ECE/TRANS/WP.29/GRE/2006/9/Rev.1
21 July 2006

PROPOSAL FOR DRAFT AMENDMENTS TO REGULATION No. 98

(Headlamps with gas-discharge light sources)

Transmitted by the expert from the Working Party "Brussels 1952" (GTB)

Figure 1

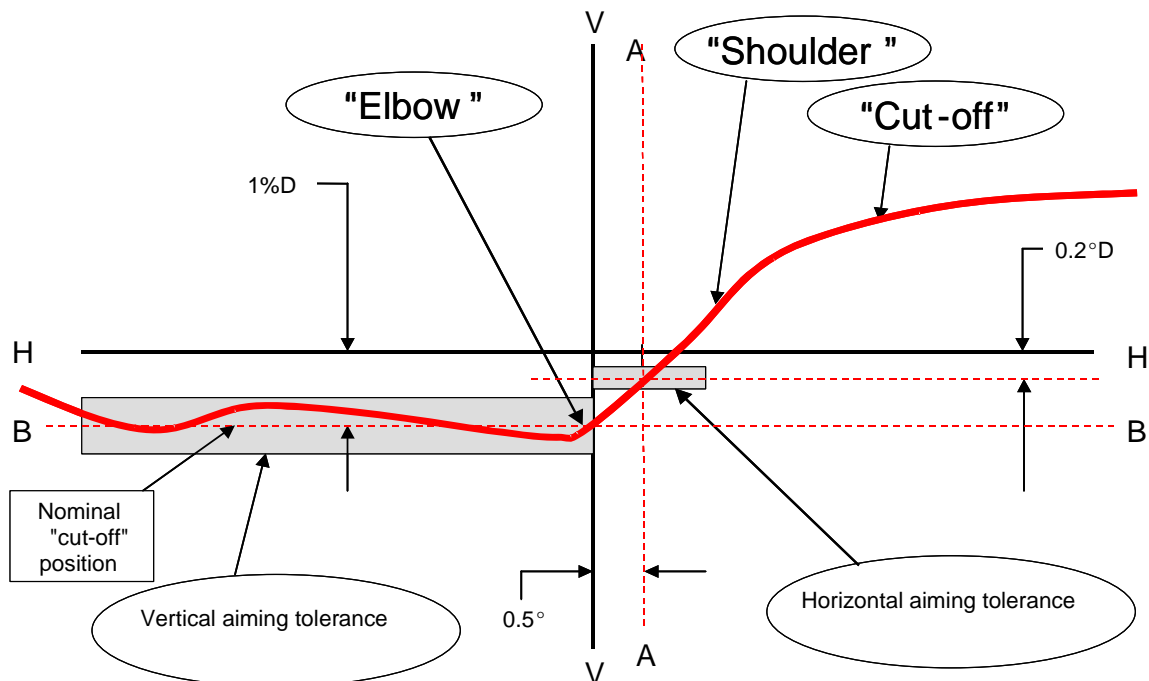
"6.2.1. **The luminous intensity distribution of the passing beam headlamp shall incorporate a "cut-off" (see figure 1 below), which enables the headlamp to be adjusted correctly for the photometric measurements and for the aiming on the vehicle.**

6.2.2. **The headlamp shall be visually aimed by means of the "cut-off" (see figure 1 below) as follows:**

6.2.2.1. **for vertical adjustment: the horizontal part of the "cut-off" is moved upward from below line B and adjusted to its nominal position one per cent (25 cm) below the H-H line;**

6.2.2.2. for horizontal adjustment: the "elbow-shoulder" part of the "cut-off" shall be moved:

- (a) for right hand traffic from right to left and shall be horizontally positioned after its movement so that:
- (b) above the line $0.2^\circ D$ its "shoulder" shall not exceed the line A to the left and
- (c) on the the line $0.2^\circ D$ or below its "shoulder" should cross the line A and
- (d) the kink of "elbow" should be primarily on the V-V line;

Figure 1: Measurement of "cut-off" quality

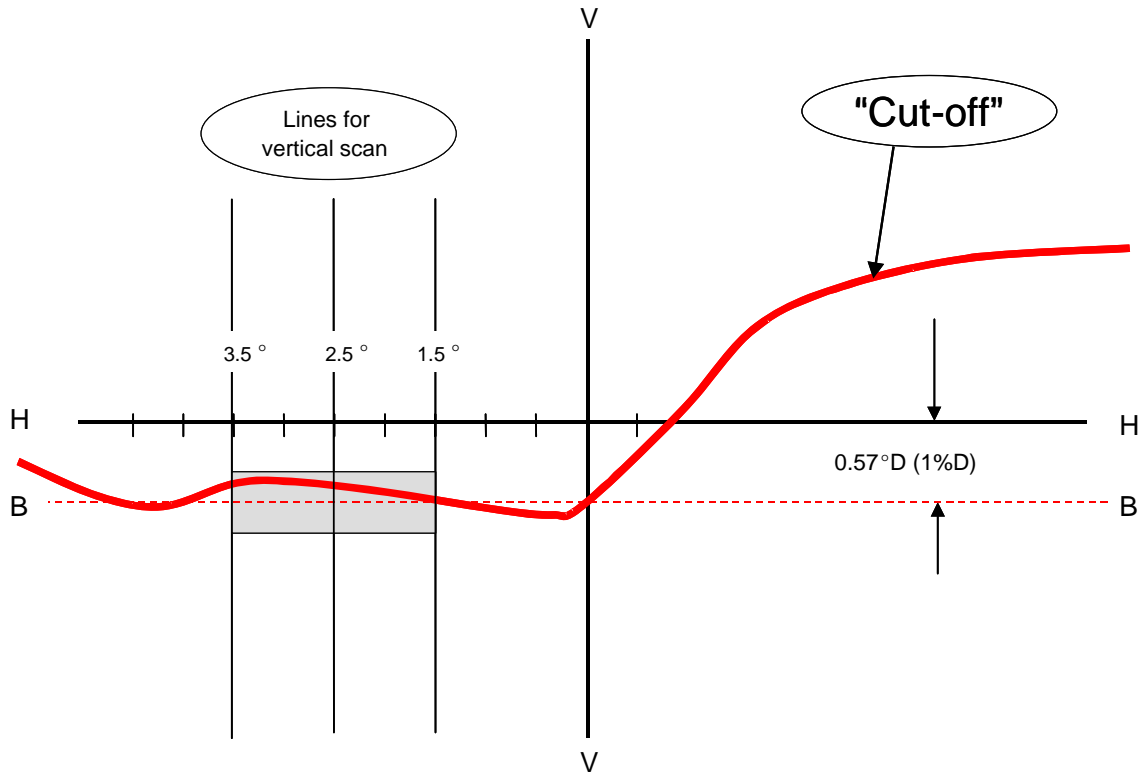
2.3. **Linearity**

The part of the horizontal "cut-off" that serves for vertical adjustment shall be horizontal between 1.5° and 3.5° from the V-V line (see figure 1 below).

(a) The inflection points of the "cut-off" gradient at the vertical lines at 1.5°, 2.5° and 3.5° shall be determined by the equation:

(b) The maximum vertical distance between the inflection points determined shall not exceed 0.2 °.

Figure 2: Instrumental vertical and horizontal adjustment- horizontal line scan method

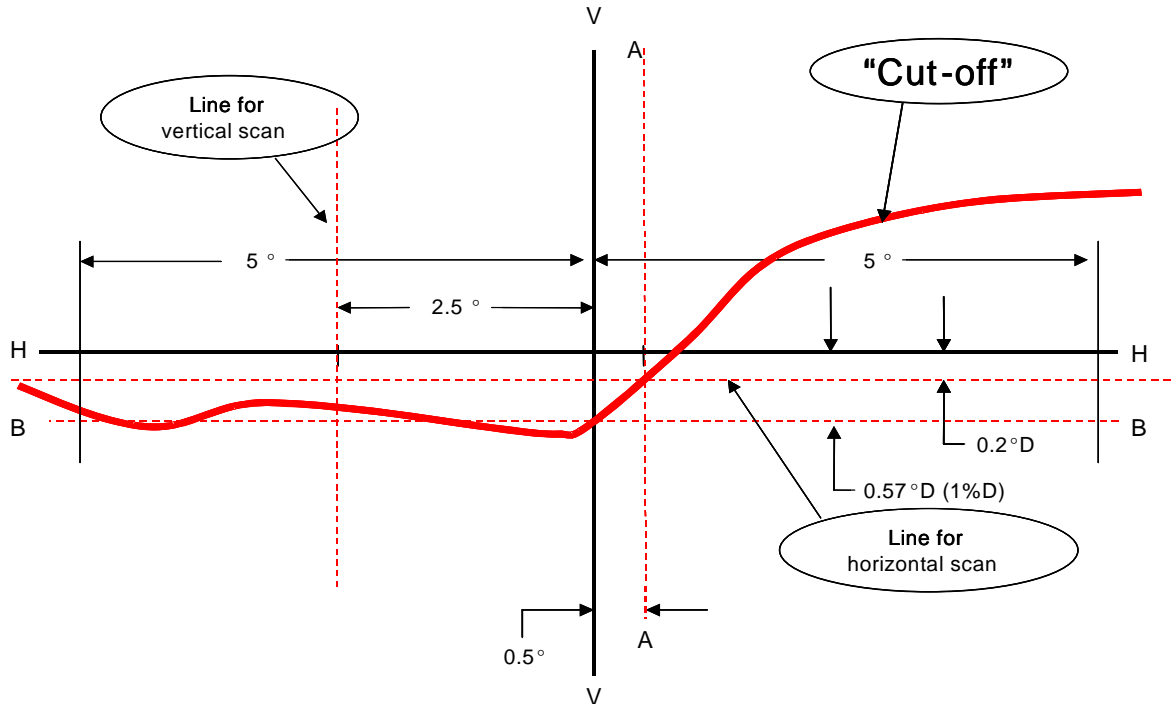
Moving upward from below the line B (see figure 2 below), a vertical scan is carried out through the horizontal part of the "cut-off" at 2.5° from V-V. The inflection point (where $d^2(\log E) / dv^2 = 0$) is determined and positioned on the line B situated one per cent below H-H.

(a) The "0.2 D line" method (see figure 2 below).

A single horizontal line at 0.2° D shall be scanned from 5° left to 5° right after the lamp has been aimed vertically. The maximum gradient "G"

determined using the formula $G = (\log E_{\beta} - \log E_{(\beta + 0.1^{\circ})})$ where β is the horizontal position in degrees, shall not be less than 0.08.

The inflection point found on the 0.2 D line shall be positioned on the line A.

Figure 3: Instrumental vertical and horizontal adjustment-three line scan method

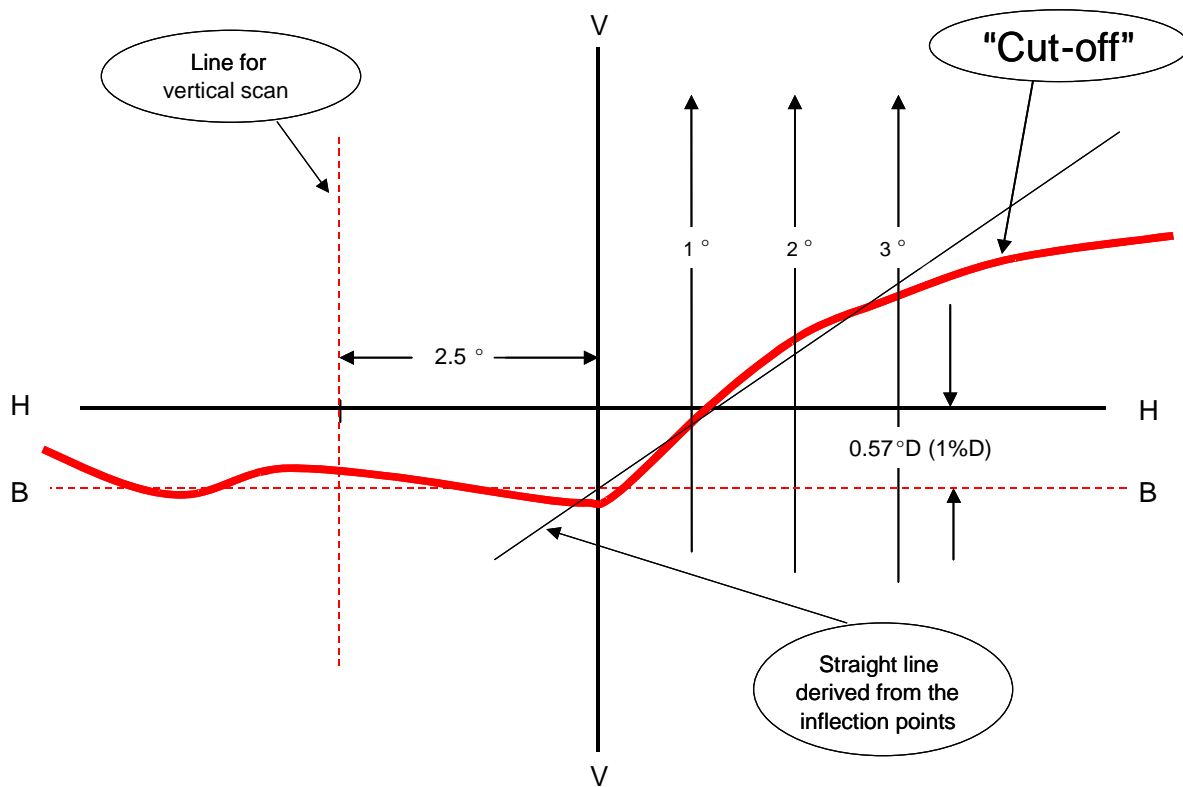
(b) The "3 line" method (see figure 3 below)

Three vertical lines shall be scanned from 2° D to 2° U at 1°R, 2°R, and 3°R after the lamp has been aimed vertically. The respective maximum gradients "G" determined using the formula:

where β is the vertical position in degrees, shall not be less than 0.08. The inflection points found on the three lines shall be used to derive a straight line. The intersection of this line and the line B found while performing vertical aim shall be placed on the V line.
